SUBJECT: PLANS AND PROPOSAL ADDENDUMS
PROJECT: STP 2023 (675)MM CONTROL: 1433-02-044
COUNTY: COMAL
LETTING: 05/04/2023
REFERENCE NO: 0419

PROPOSAL ADDENDUMS

DESCRIPTION OF ABOVE CHANGES
(INCLUDING PLANS SHEET CHANGES)

T:\Groups\VOO_KATY\PROJECTS\TXD117105\11 FM 2252\CADD\SHEETS\FM2252_POND01.dgn
4/25/2023 9:18:59 AM

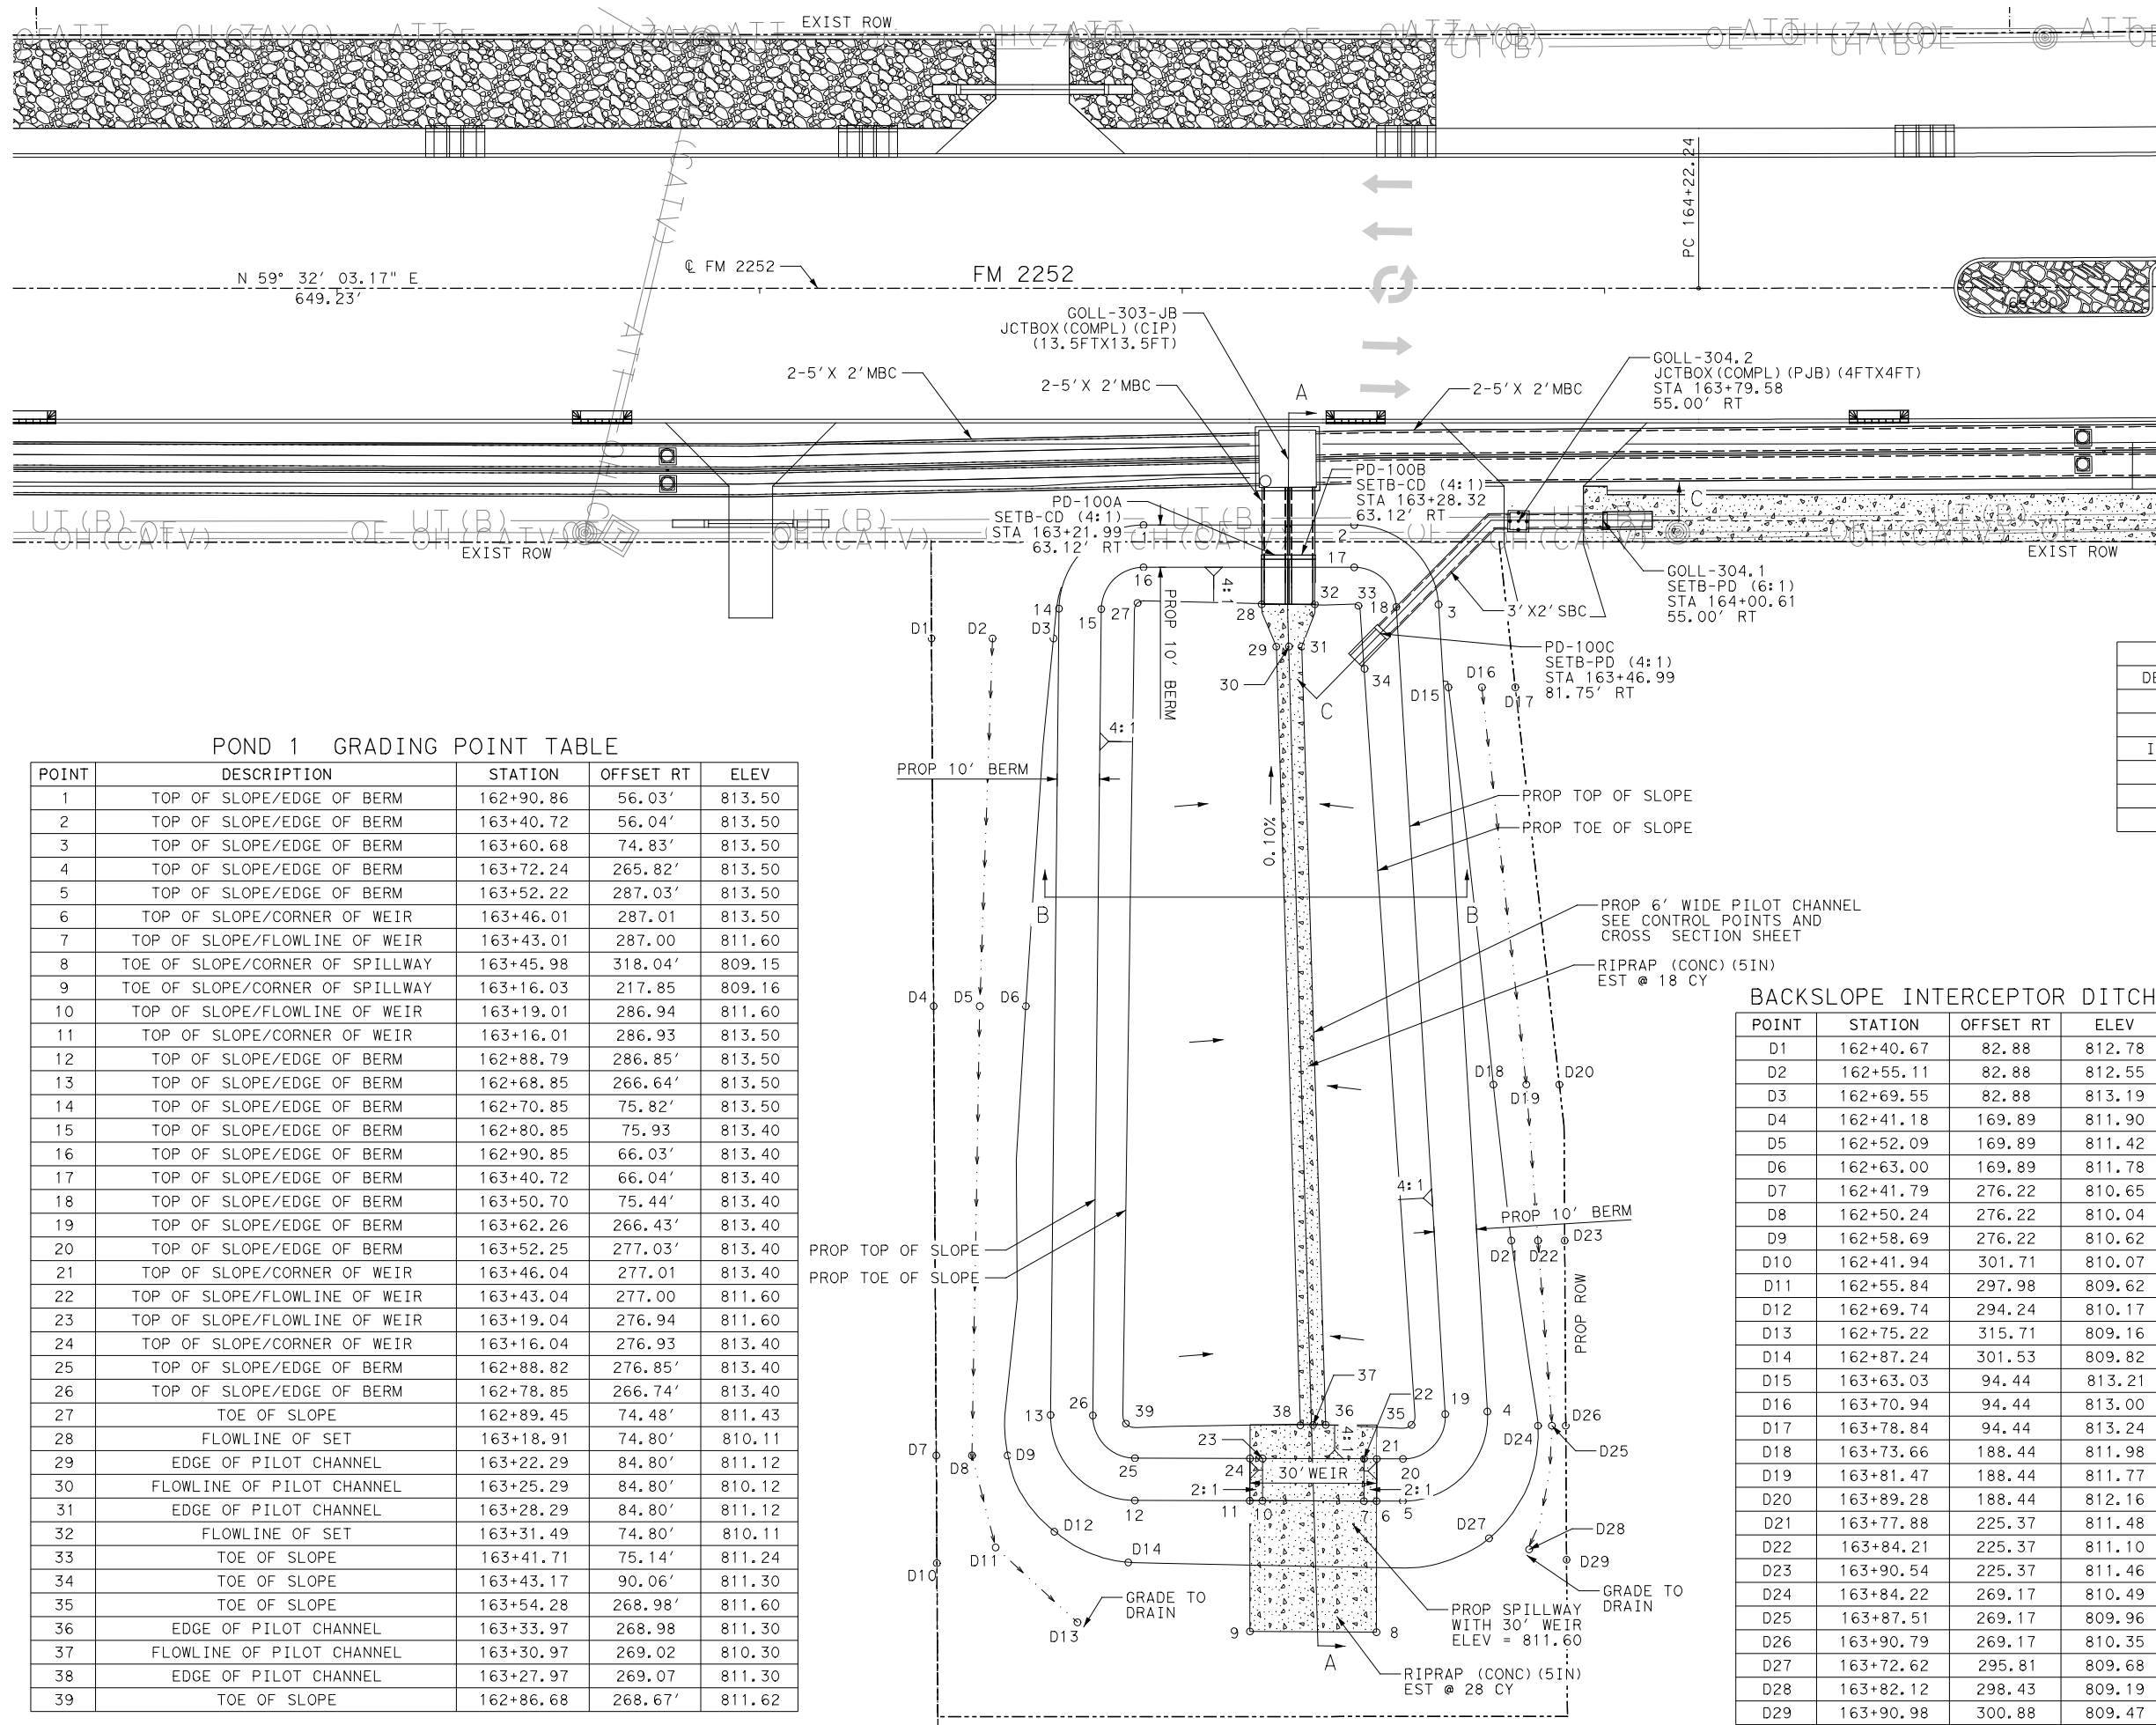
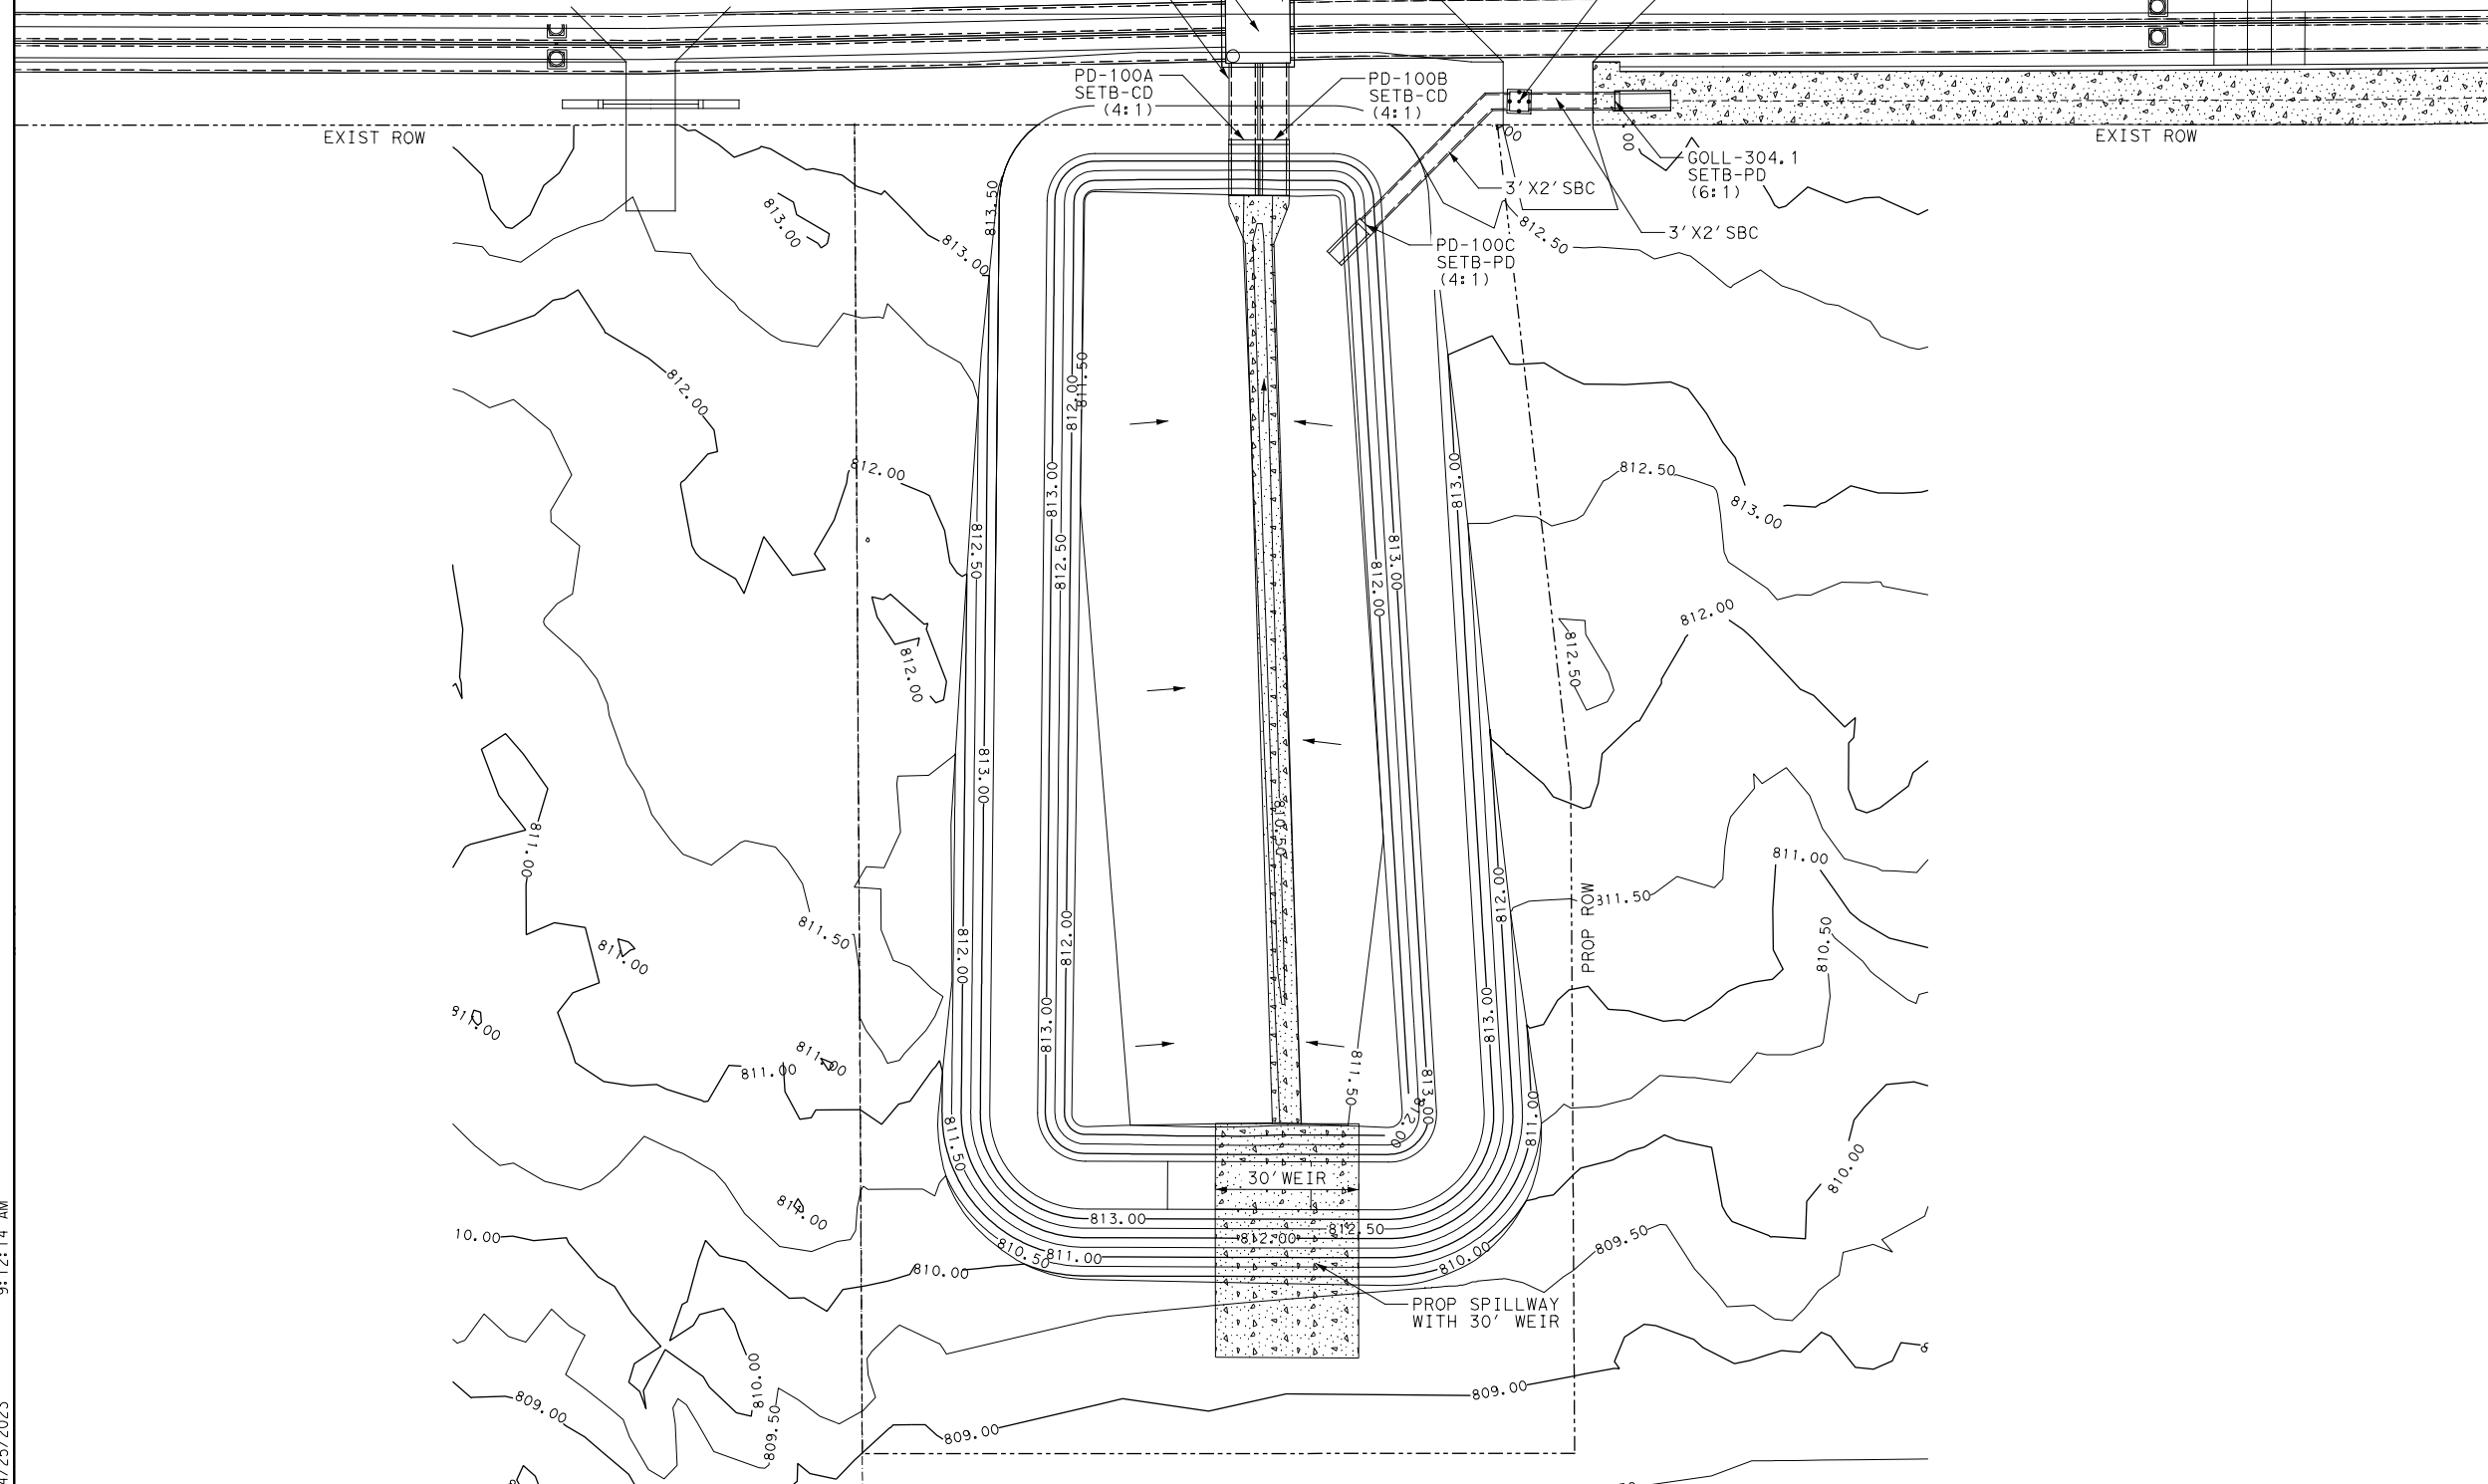
SHEETS 717-719: REVISED DETENTION POND LAYOUT GRADNG AND OUTFALL
